ADDENDUM NO. 1

DATE: August 15, 2018
FROM: City of Grand Junction Purchasing Division
TO: All Offerors
RE: Lewis Wash Bridge Replacement (Re-Bid) IFB-4548-18-DH

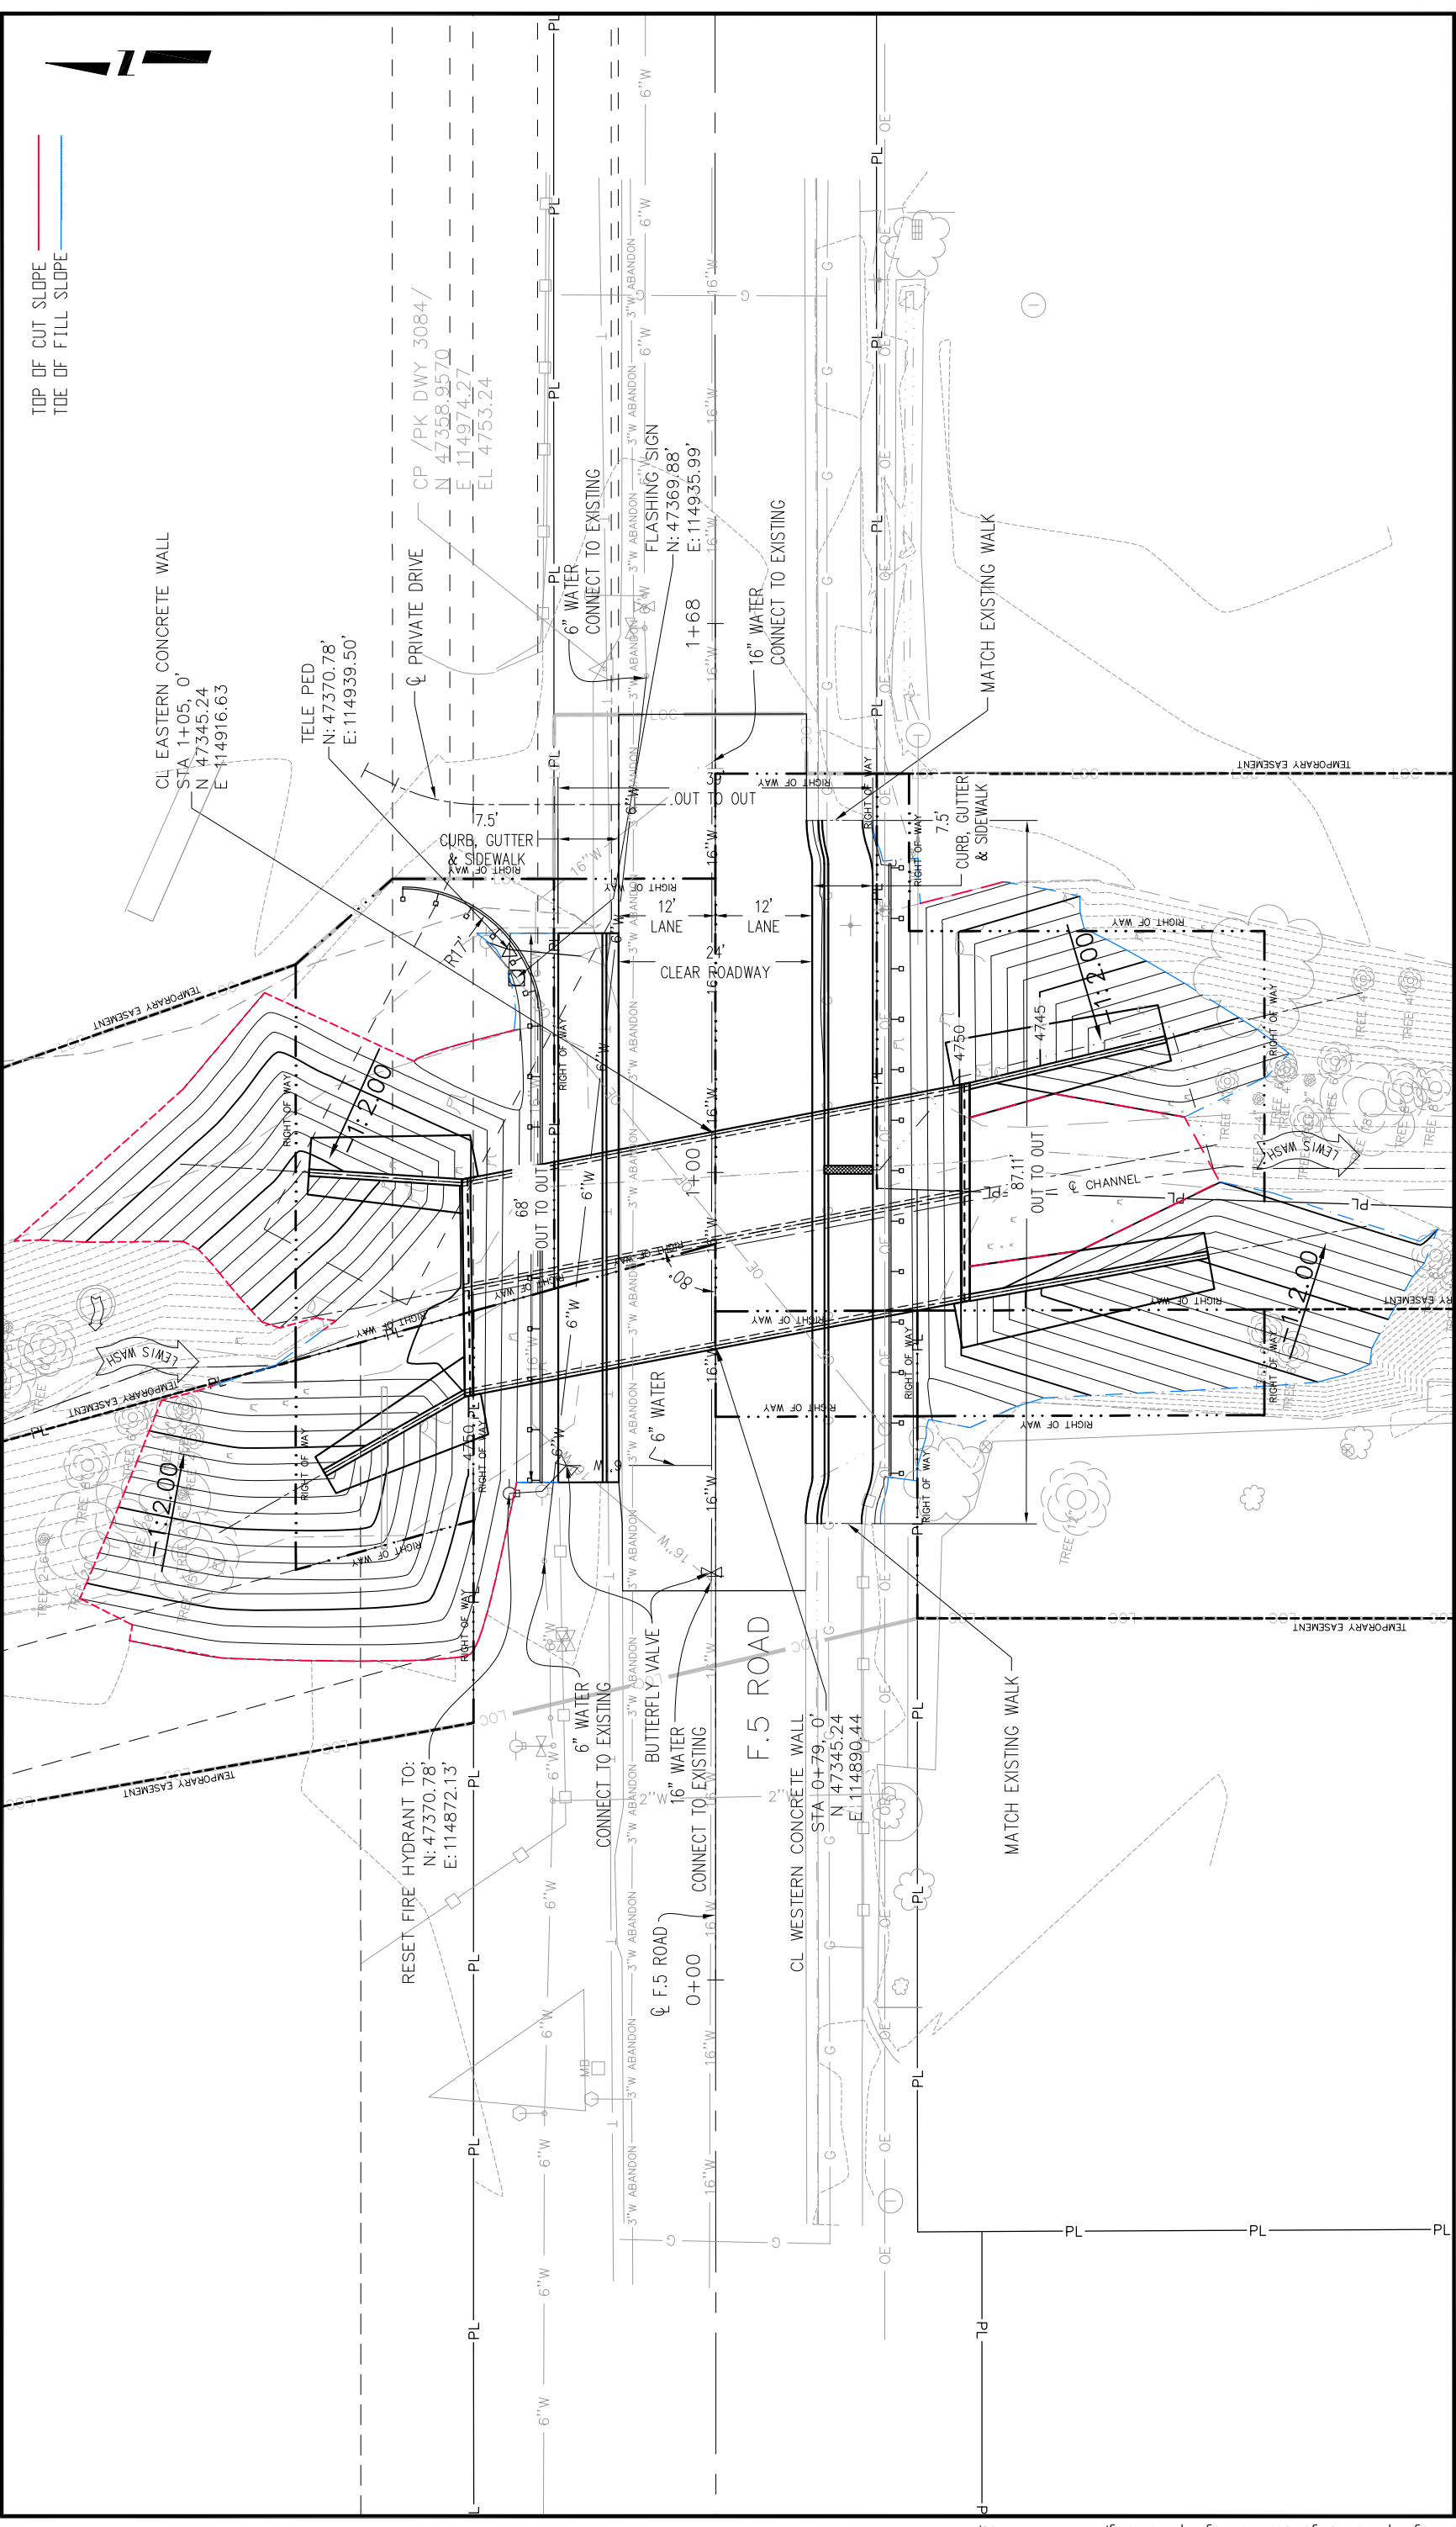
4. Q. Please provide contour elevations on the grading drawing.
 - A. Existing and proposed grading contour elevations will be shown in the drawings. The drawings affected will be re-issued under Addendum #1.

<table><tr> <th>Date:</th> <th>Comments</th> <th>Init.</th> </tr><tr> <td>2018-08-14</td> <td>Proposed Contours Shown</td> <td>KA</td> </tr></table>

F.5 ROAD CURB & GUTTER
FLOW LINE PLAN & PROFILE

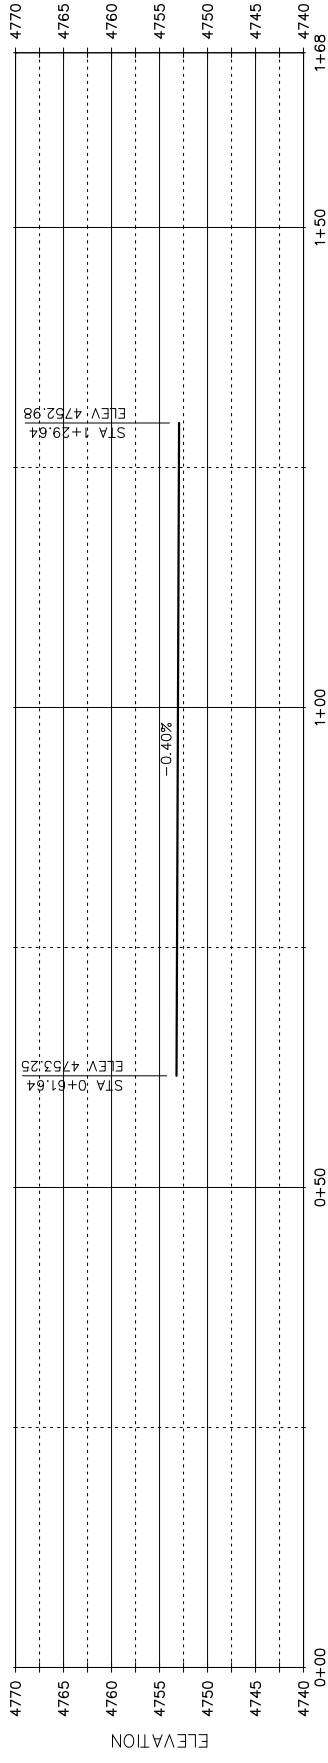
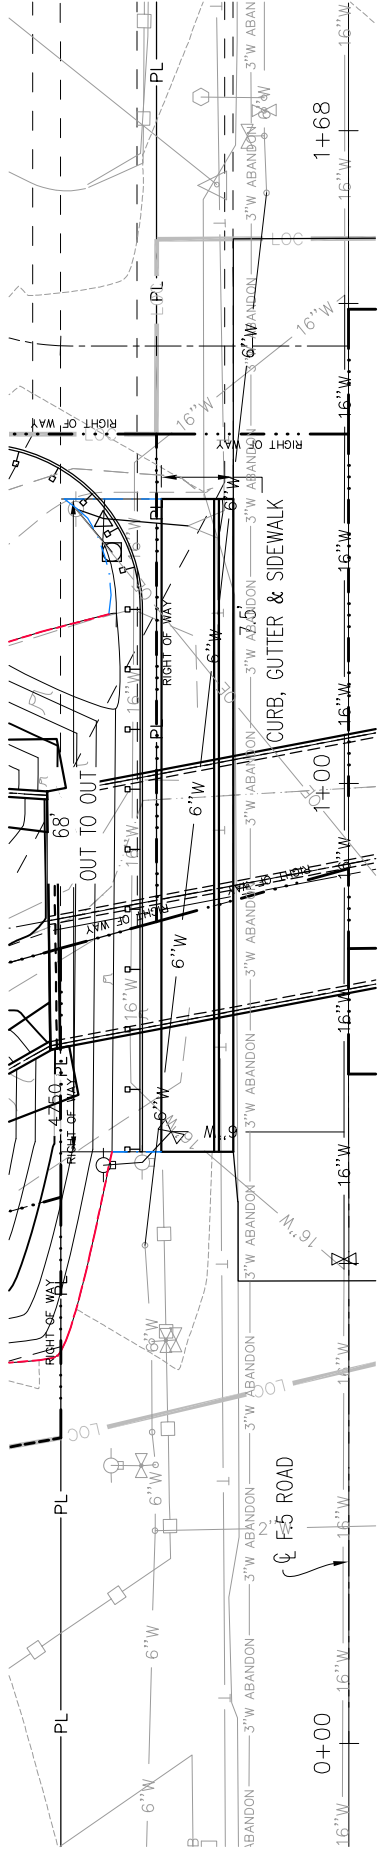
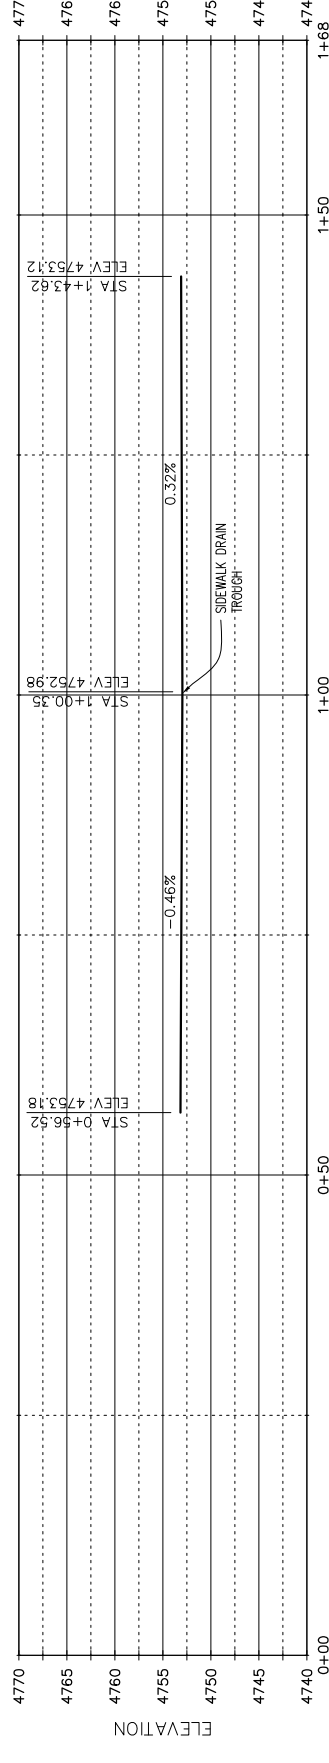
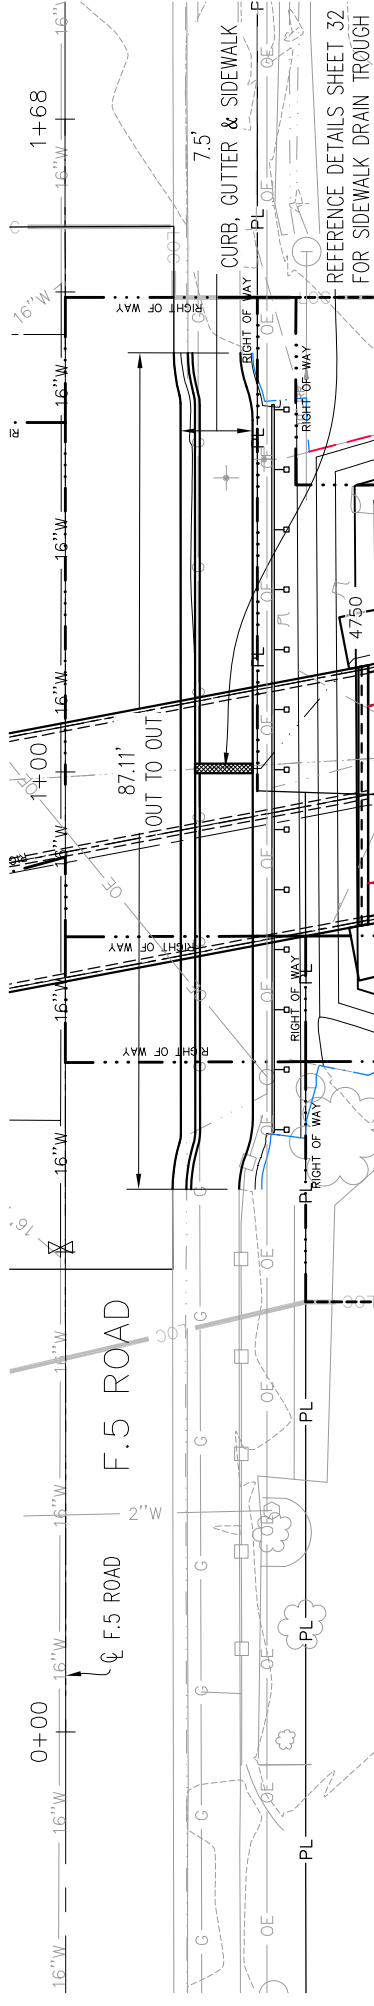
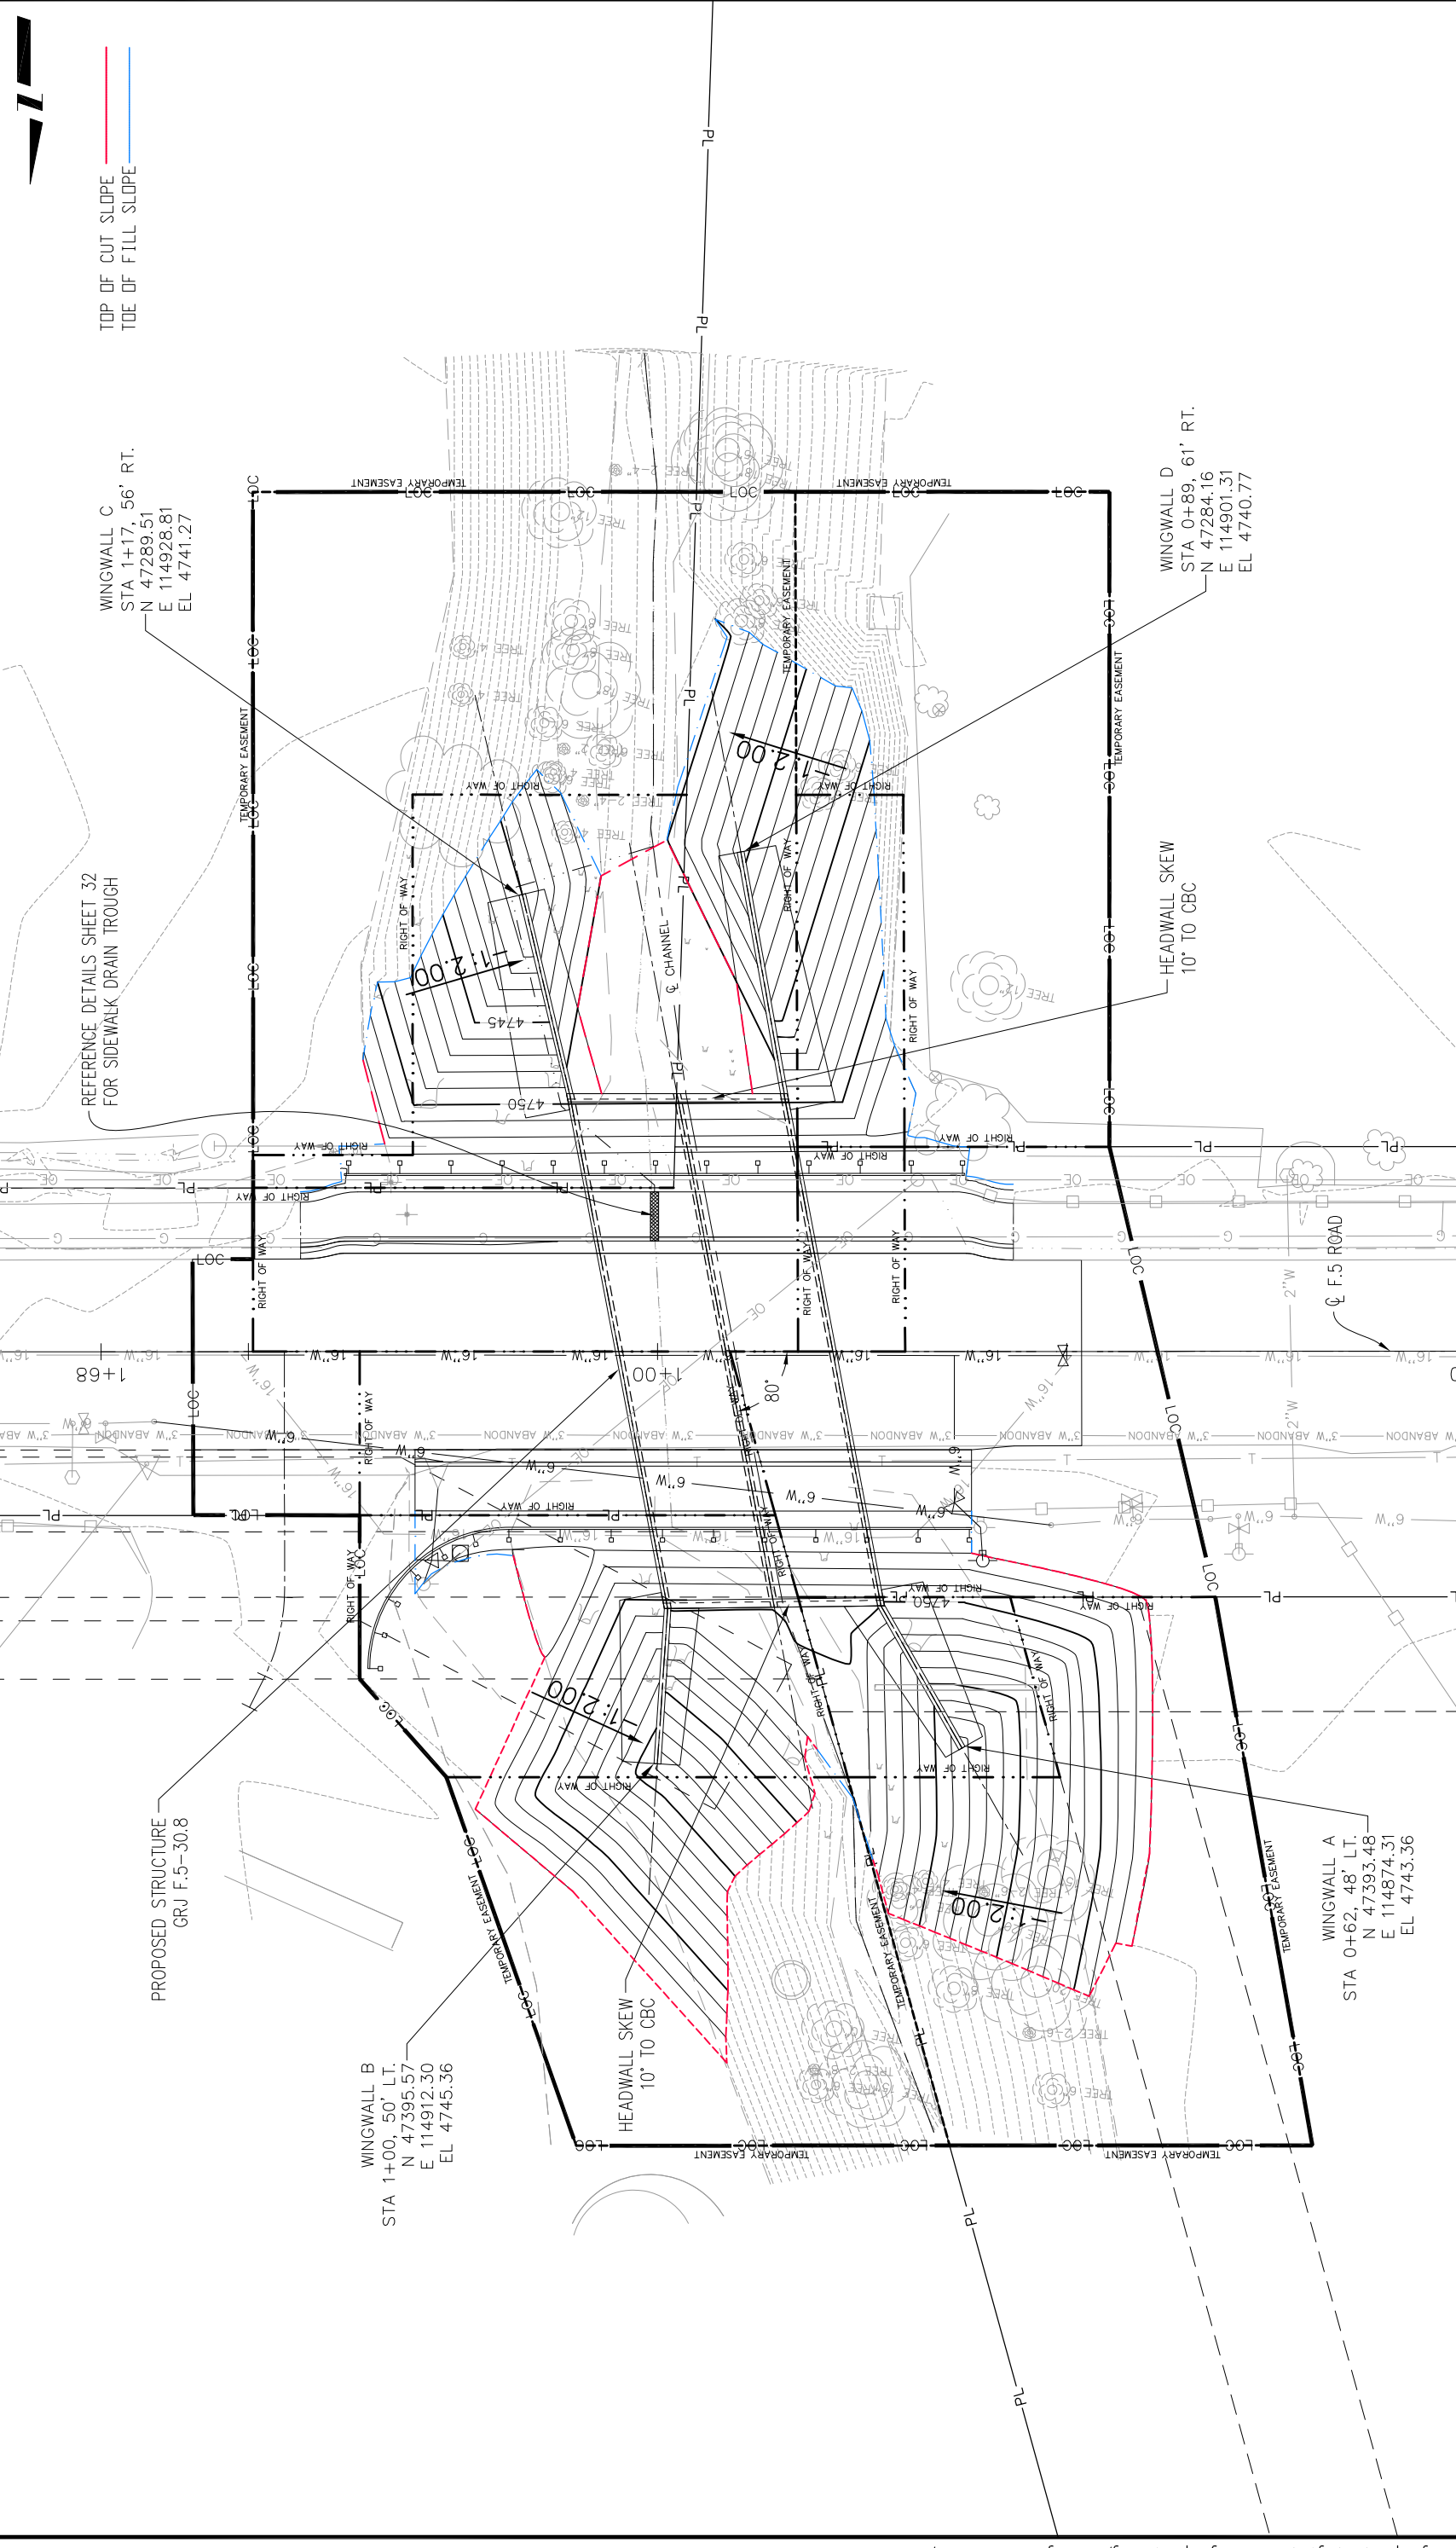
Date: 2018-08-14
Comments: Proposed Contours Shown
Init.: KA
